Planning Application Consultation Response

Application Number	DM/25/2071
Response Date	12.03.26
Site Location	Land To Rear Off Chideok Valebridge Road Burgess Hill West Sussex RH15 0RT
Development Description	Construction of 2 no houses with detached garages and retrospective permission for the creation of a new access from Valebridge Road (Flood Risk Assessment received 12.01.2026) (Tree information received 18.02.2026) (Revised description agreed 19.02.2026)
Recommendation¹	Objection

Figure 1: Risk of Flooding from Surface Water present day 2025 (Source: EA)

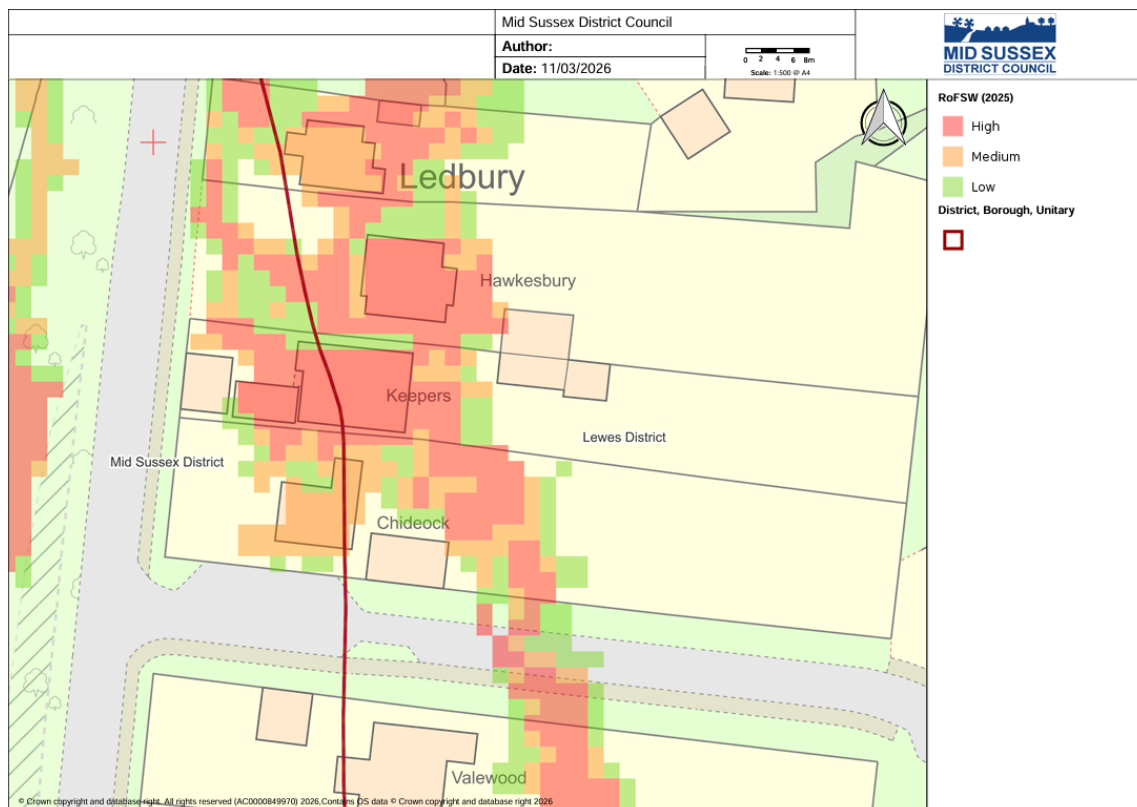
The Risk of Flooding from Surface Water mapping suggests the site is shown to be at “Very Low” to “High” surface water flood risk (comparable to flood zones 1 and 3b) for the present day (2025) and to be at “Very Low” to “High” surface water flood risk (comparable to flood zones 1 and 3b within the climate change range of 2040 – 2060.

The area of “High” surface water is associated with a flow path which crosses the site from south to north and encroaches onto the driveway.

It is also noted that the Risk of Flooding from Surface Water mapping indicates that one of the proposed dwellings and associated garage, located within the Lewes District Council administrative area, is situated within an area identified as being at “High” risk of surface water flooding. Whilst this element of the development lies outside the jurisdiction of Mid Sussex District Council, the Flood Risk and Drainage Team consider it appropriate to highlight this risk.

Figure 2: Risk of Flooding from Surface Water –Climate Change 2040 – 2060 (Source: EA)

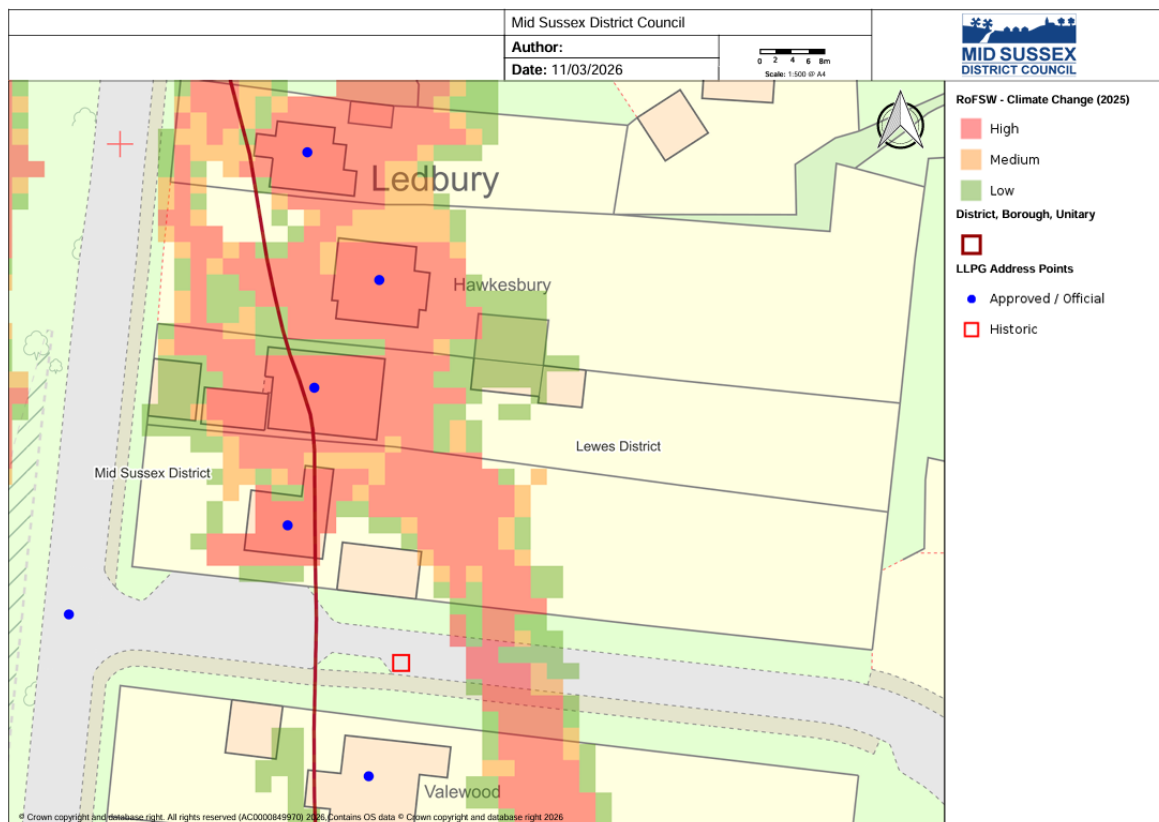
Based on the latest guidance that all sources of flooding should be considered consistently, part of the site would be considered functional floodplain (Flood Zone 3b); it’s location part within the 1:30 surface water flood extent with climate change.
